Notice of Allowability

10/534,008

VAN BERKEL, CORNELIS

EXAMINER'S AMENDMENT

FIG.1

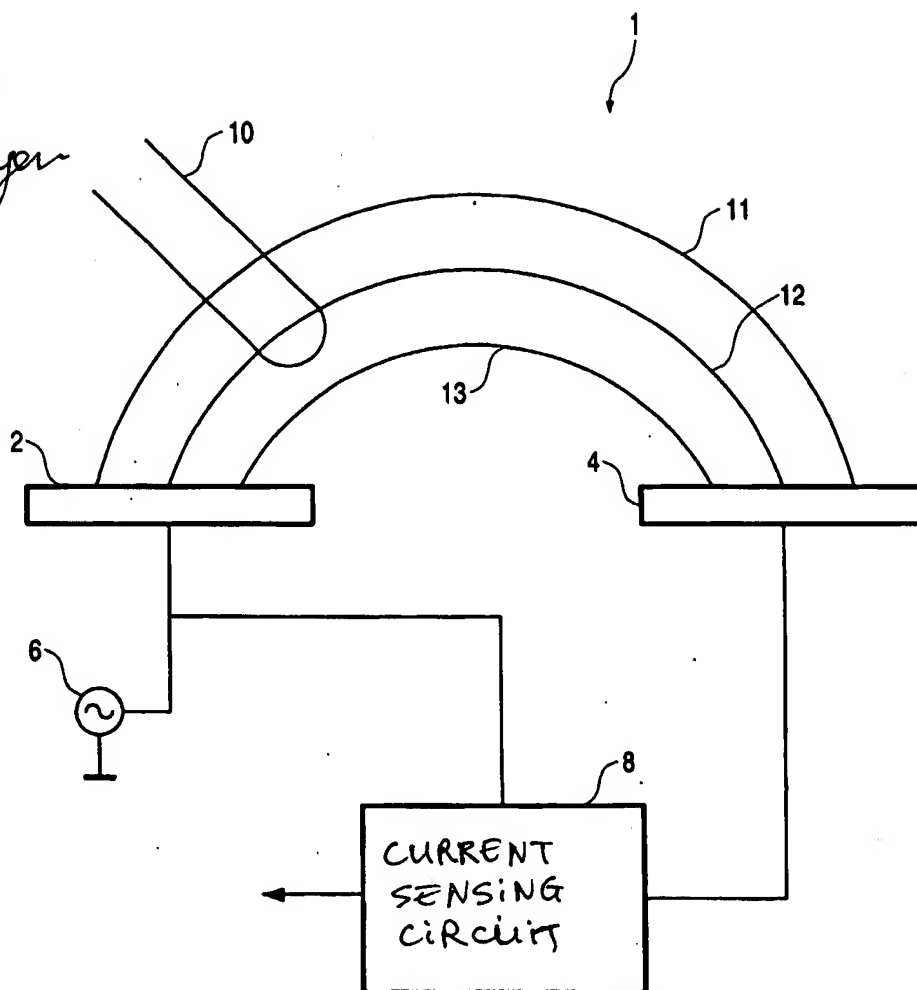
In the drawing of figure 1, box # 8 is labeled – Current Sensing Circuit –

FIG.2

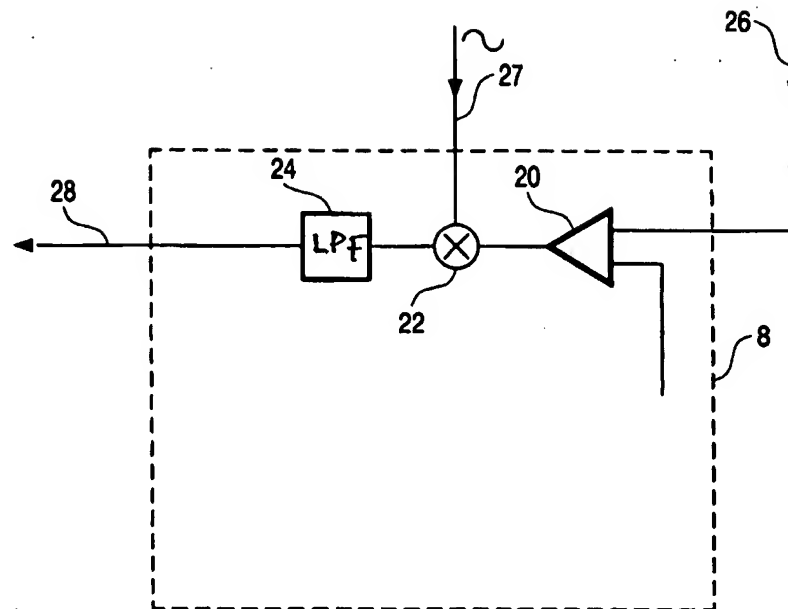
In the drawing of figure 2, box # 24 is labeled – LPF –

FIG.4

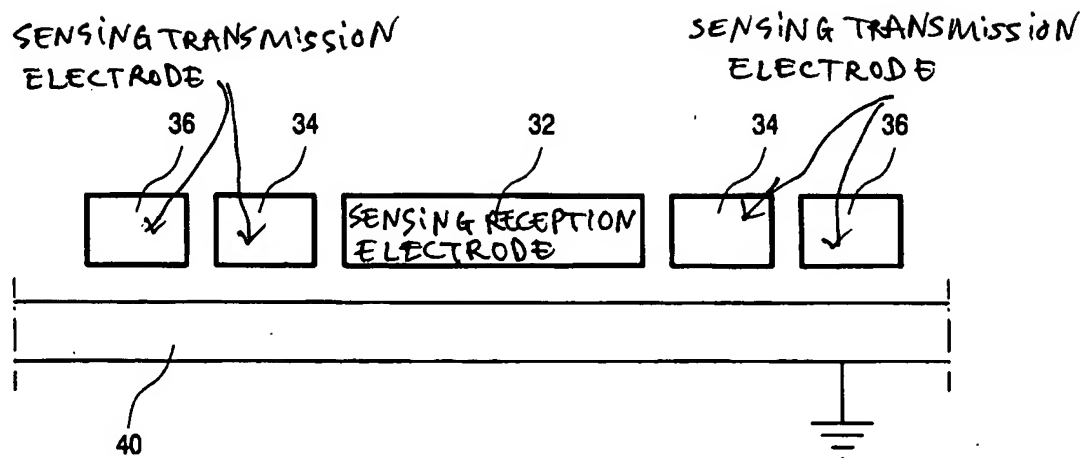
In the drawing of figure 4, box # 32 is labeled – Sensing Reception Electrode -- ; boxes 34 and 36, are labeled – Sensing transmission Electrode –

FIG. 5

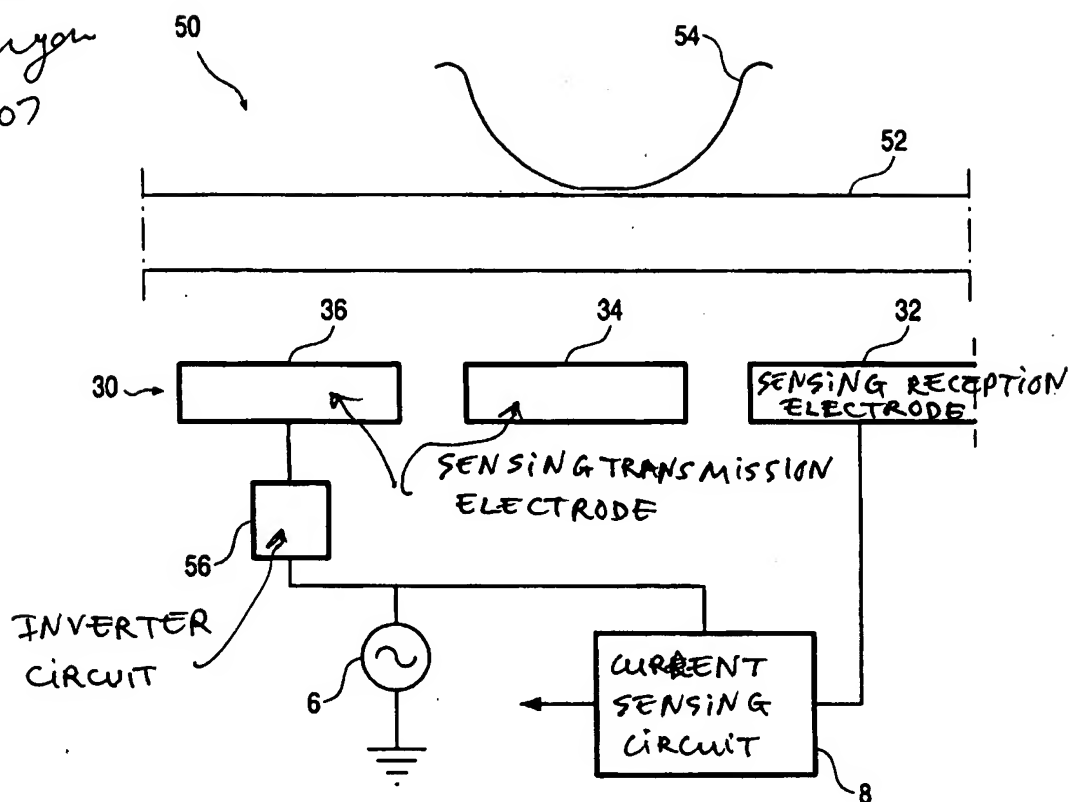
In the drawing of figure 5, box # 8 is labeled – Current Sensing Circuit --; box # 32 is labeled – Sensing Reception Electrode --; boxes # 34 and 36 are labeled – Sensing Transmission Electrode –
